Chestnut Senior Village

CHESTNUT STREET
FRANKLIN, MASSACHUSETTS

DATE	REVISED
6/15/2011	DUMPSTER LOCATION/REMOVE TREES
6/23/2011	ADDED CERTIFICATE OF VOTE NOTE

SETTLEMENT PLAN

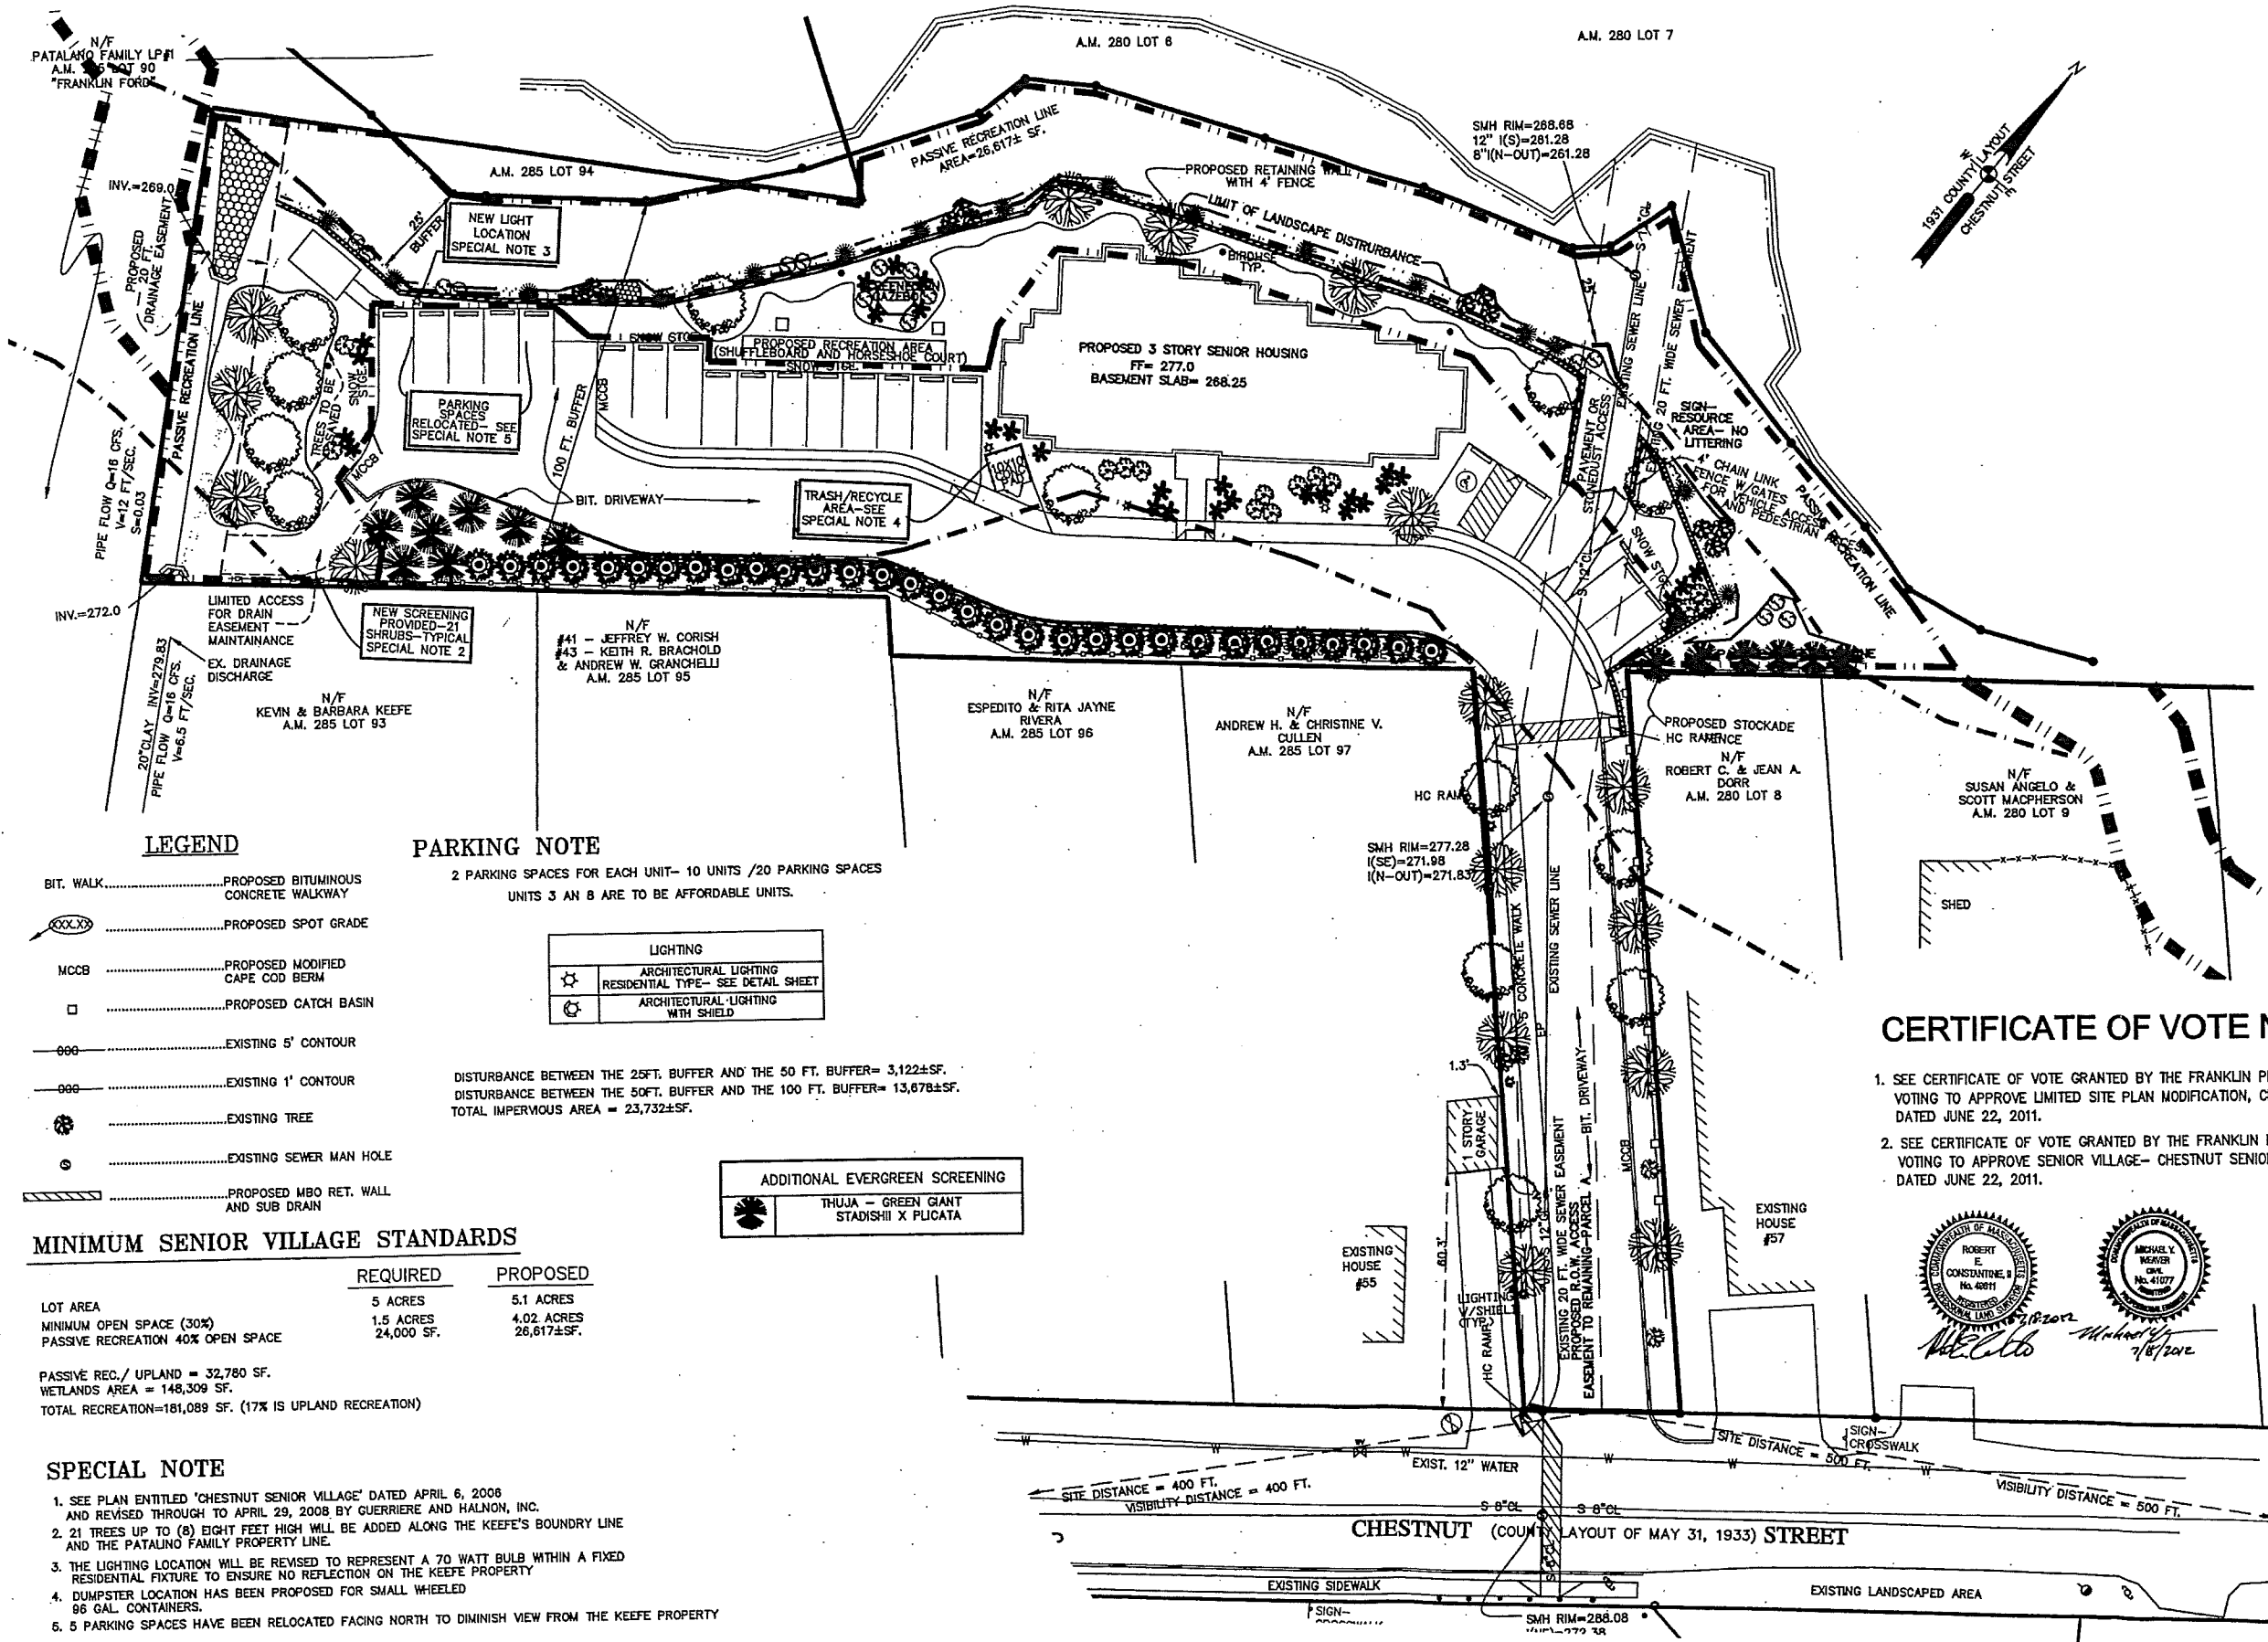
ADDITIONAL EVERGREEN SCREENING

- SEE PLAN ENTITLED 'CHESTNUT SENIOR VILLAGE' DATED APRIL 6, 2008 AND REVISED THROUGH TO APRIL 29, 2008 BY GUERRIERE AND HALNON, INC.
- 21 TREES UP TO (8) EIGHT FEET HIGH WILL BE ADDED ALONG THE KEEFE'S BOUNDARY LINE AND THE PATALANO FAMILY PROPERTY LINE.
- THE LIGHTING LOCATION WILL BE REVISED TO REPRESENT A 70 WATT BULB WITHIN A FIXED RESIDENTIAL FIXTURE TO ENSURE NO REFLECTION ON THE KEEFE PROPERTY
- DUMPSTER LOCATION HAS BEEN PROPOSED FOR SMALL WHEELED 96 GAL. CONTAINERS.
- 5 PARKING SPACES HAVE BEEN RELOCATED FACING NORTH TO DIMINISH VIEW FROM THE KEEFE PROPERTY
